ITEM 1.2 (e)

85 Harrington Street
The Rocks
GOLDEN AGE & HANNAS THE ROCKS

TITLE
RESPONSE TO DoPE
ITEM 1.2 (e)

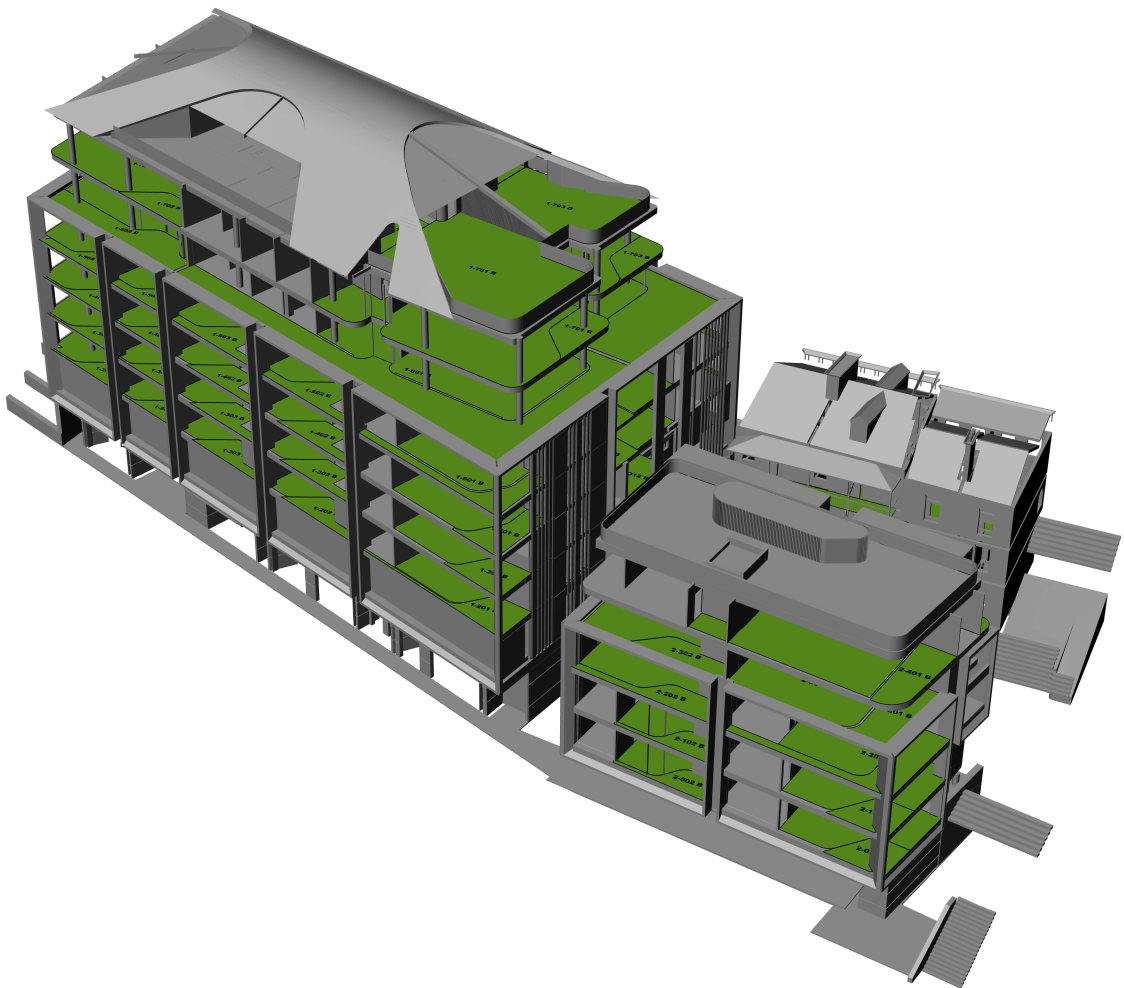
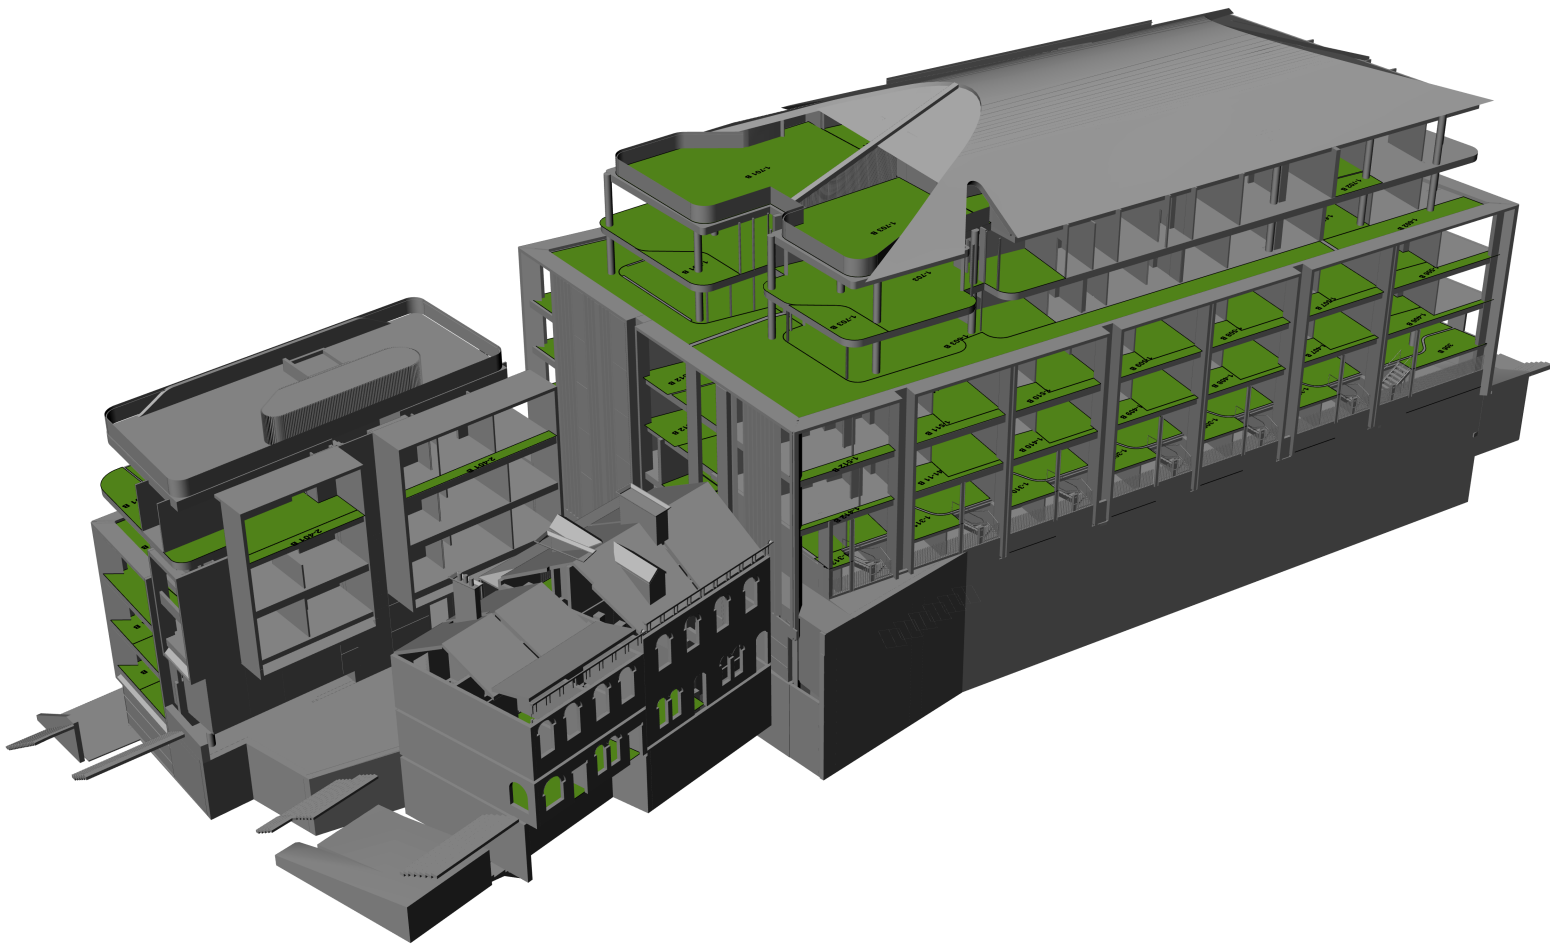
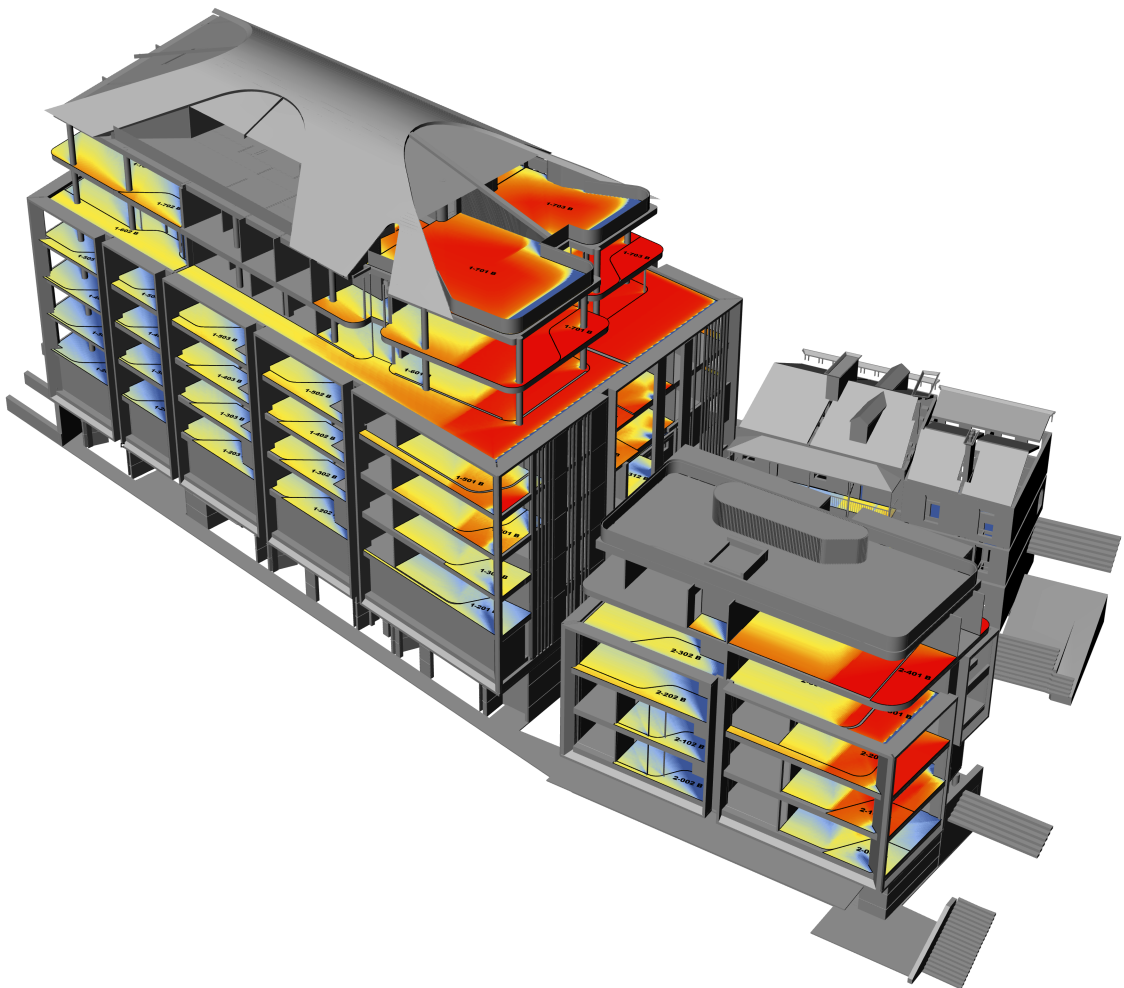
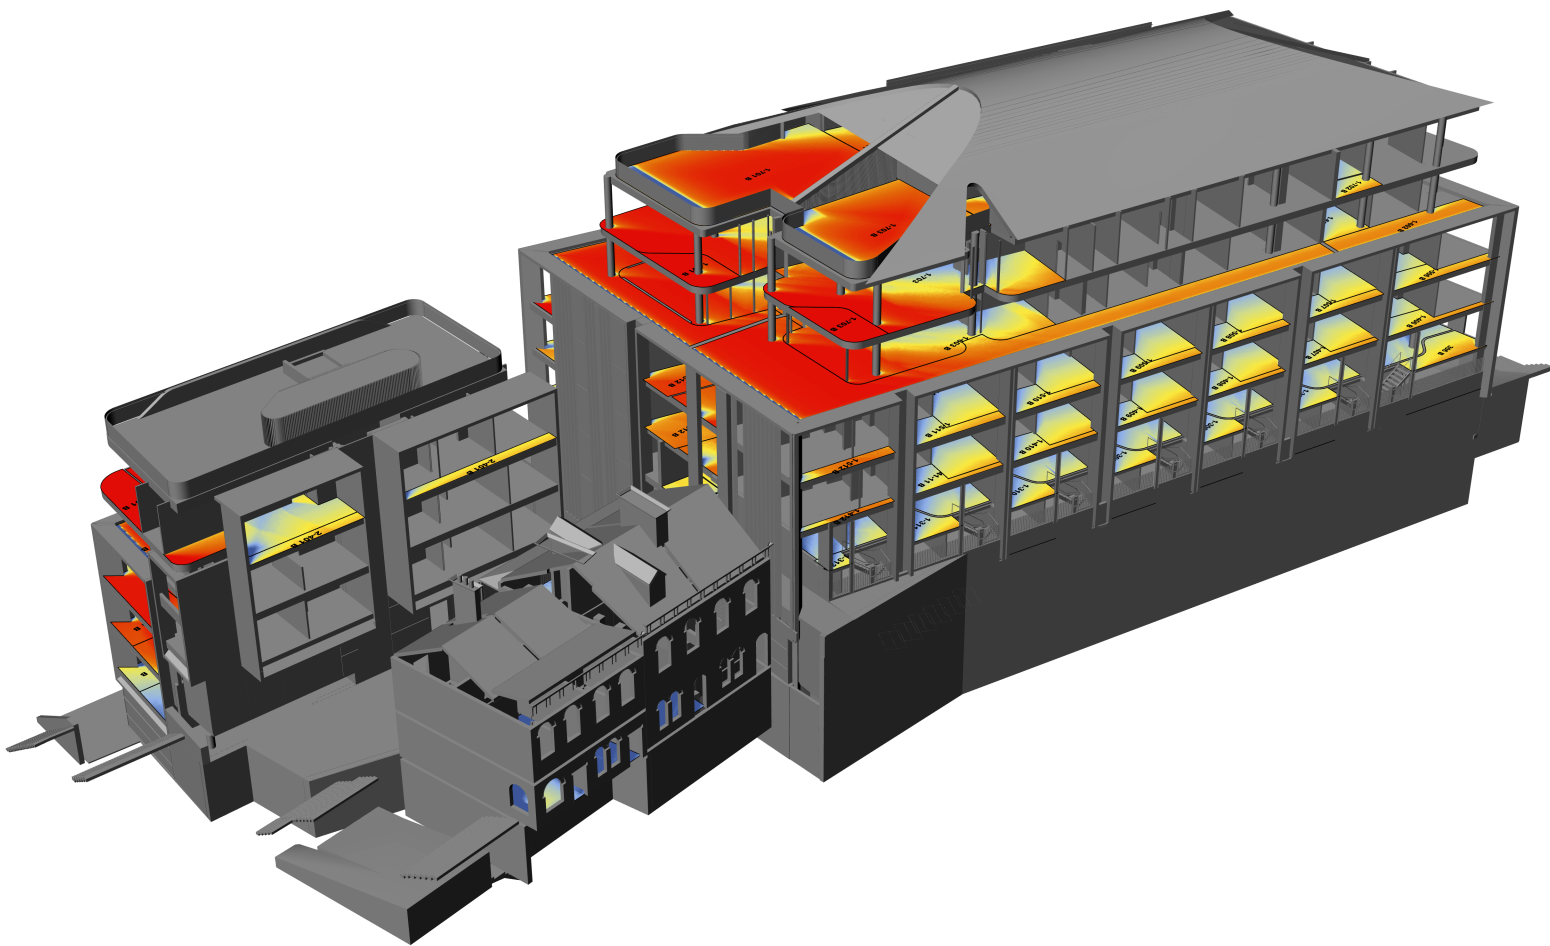
Issue/ Objection:
Solar Access

Description:
The proposal indicates 70% of units will receive at least two hours solar access in midwinter (9am to 3pm) and all units will receive at least one hour of solar access in midwinter. Please provide a solar access study demonstrating the above including consideration of the proportion/area of the living rooms and balconies receiving solar access.

Response
The site is located in a dense, urban, city setting. The topography of the site relies upon a design response resulting in a building with a North/South orientation. As such all apartments face an East or West direction and are afforded good solar amenity. The building results in **no single aspect south facing apartments**. An extensive solar access study has been undertaken to show that 70% of units will receive at least 2 hours solar access in midwinter (9am to 3pm)

TOTAL NUMBER OF APARTMENTS: 56
APARTMENTS ACHIEVING 2 HOURS: 56

TOTAL: 56 OUT OF 56 APARTMENTS =100%
